Agreement No. CE 82/2022 (WS)
In-situ Reprovisioning of Tsuen Wan Water Treatment Works – Investigation, Design and Construction
Further Information of S.16 Application

Further to S.16 Planning Application No. A/TW/549, we would like to enclose the following documents for further information of the S.16 Application:

Responses to Comments

Figure No.	Scale	Figure Title
22	-	RENDERING
	Date May 2026	Source Photomontage for illustrative purpose

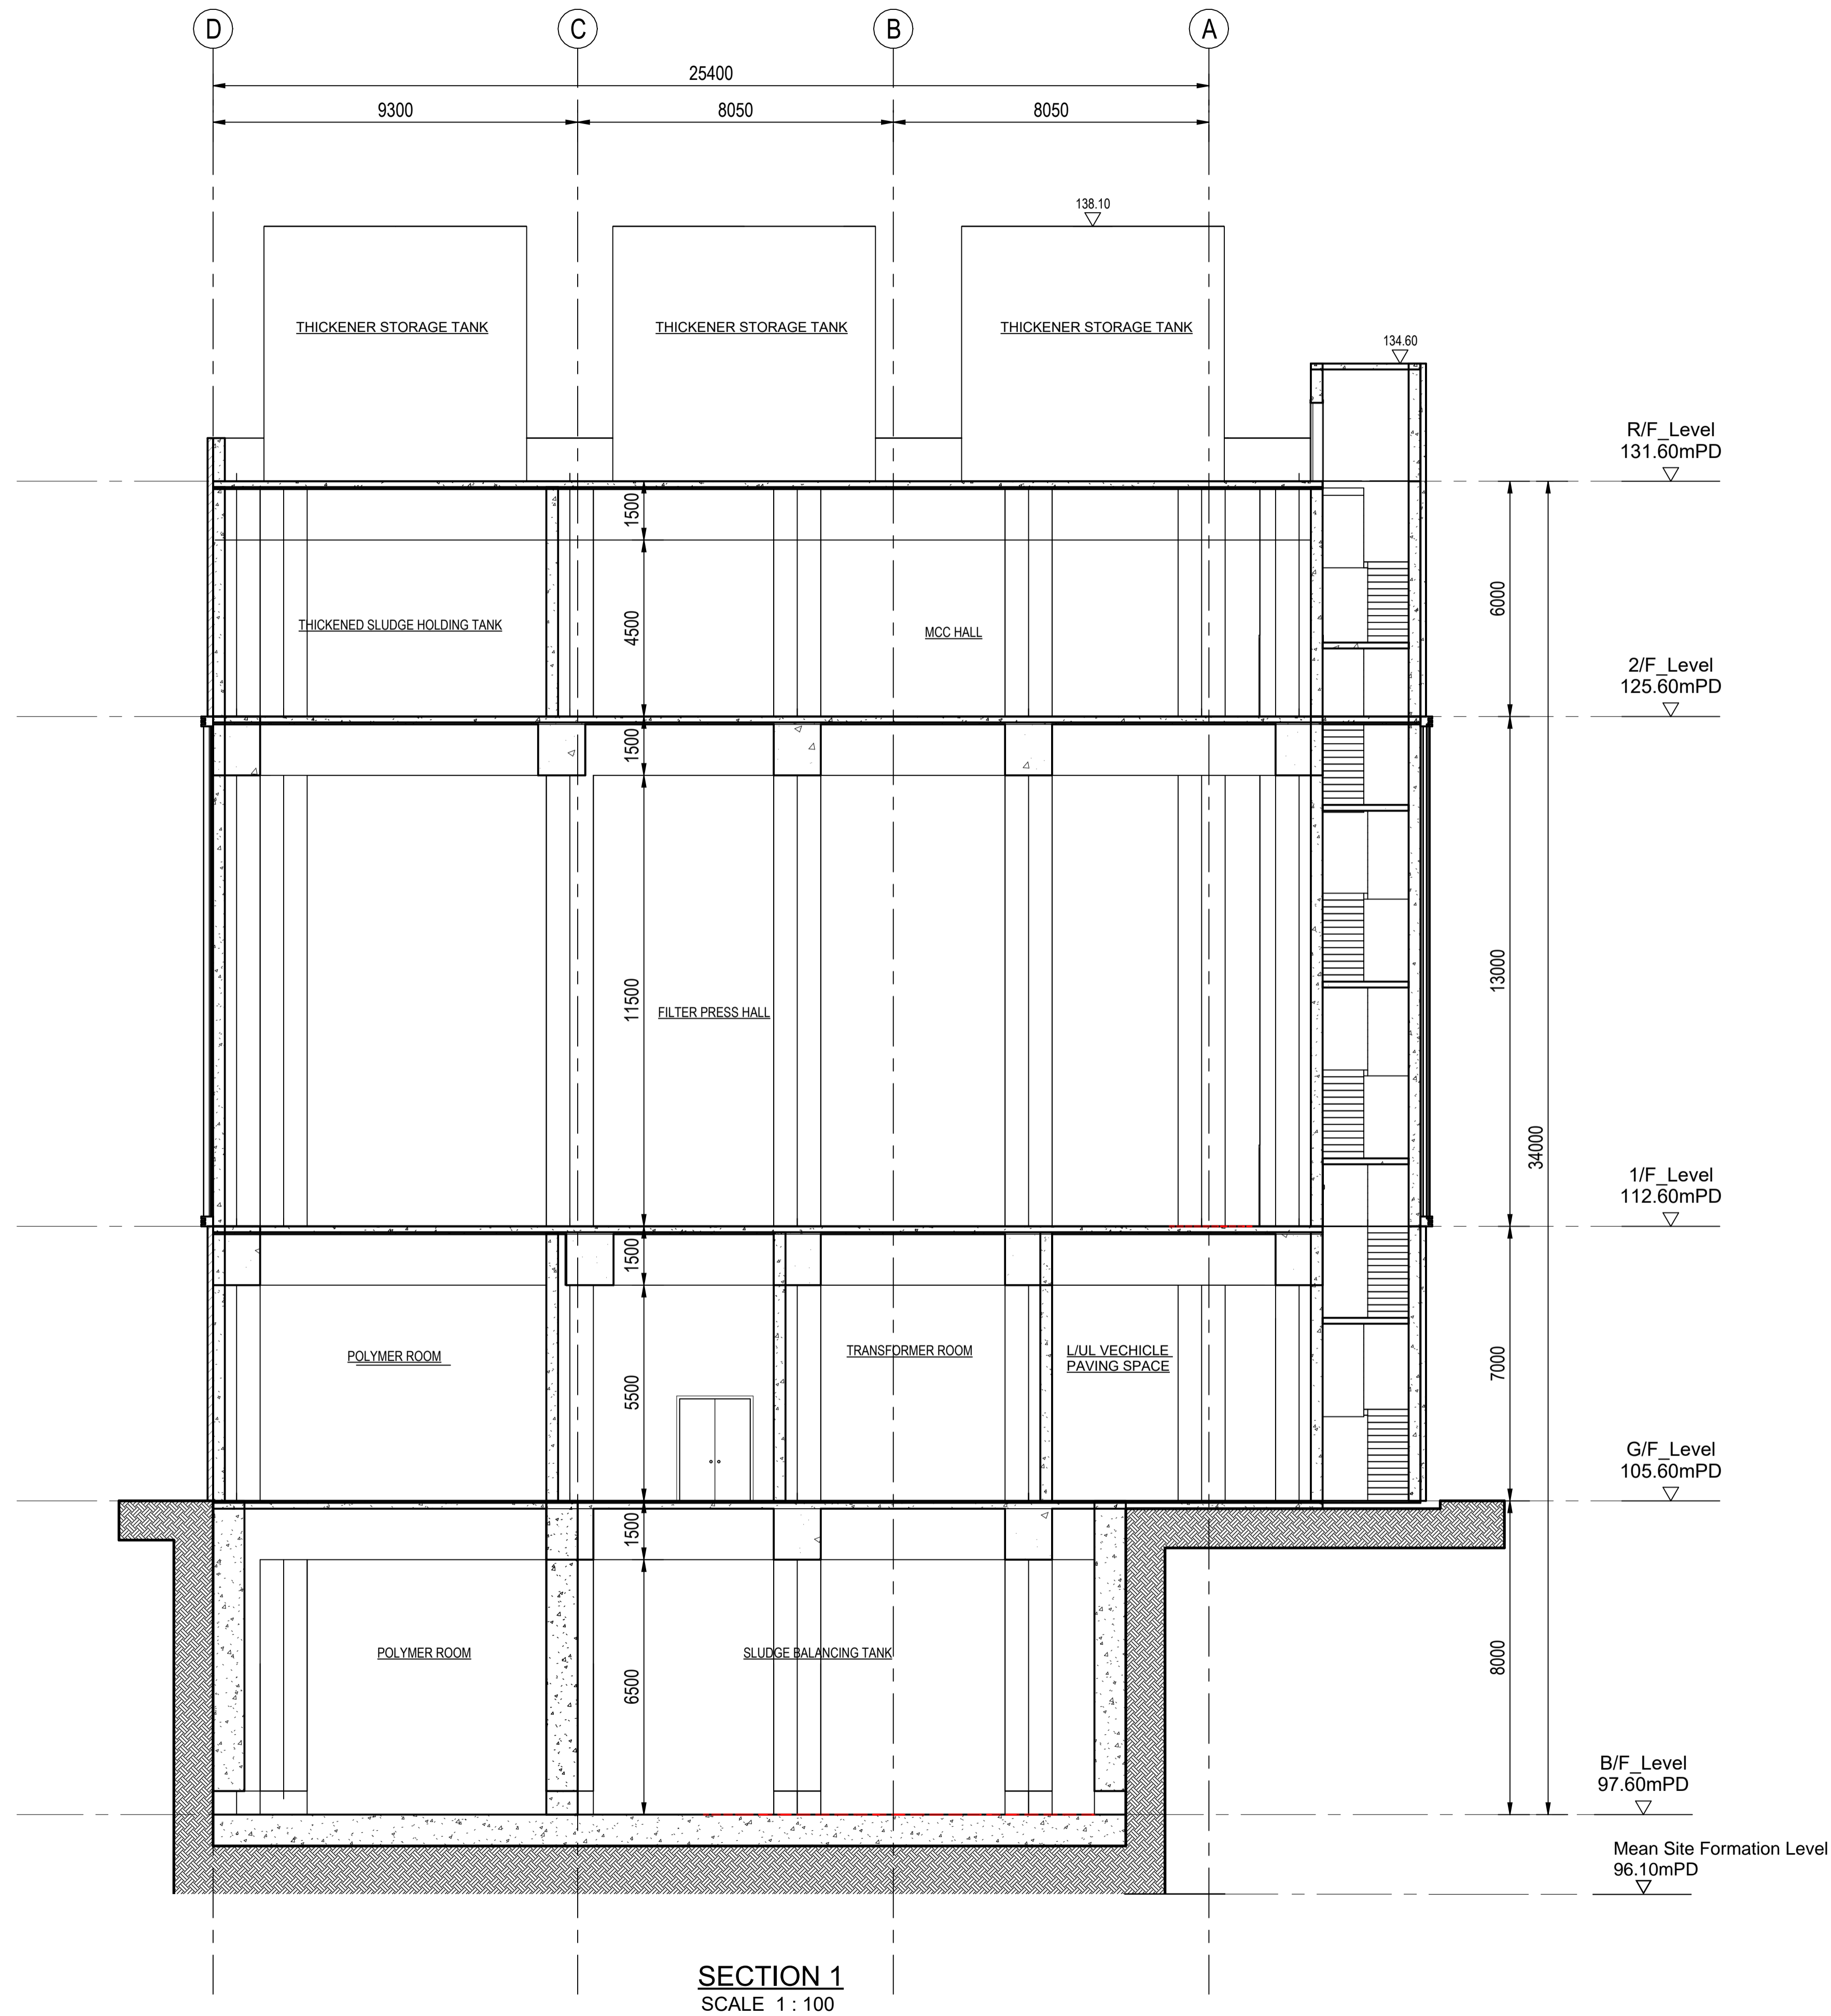
<p>Planning Statement</p>	<p>No images provided of the finished building, one has to rely on the as ever effusive description provided on page 21. The steel fins sound dodgy. Steel can corrode and rust in harsh conditions and the location is on a hill side so subject to the impact of heavy rainfall and storms. But then Binnies is not big visuals.</p>	<p>Please note that a photomontage of the proposed development is incorporated in Figure 22 to show the finished building.</p> <p>For the appearance of the proposed development, materials with higher resistance to corrosion will be adopted at the detailed design stage.</p>
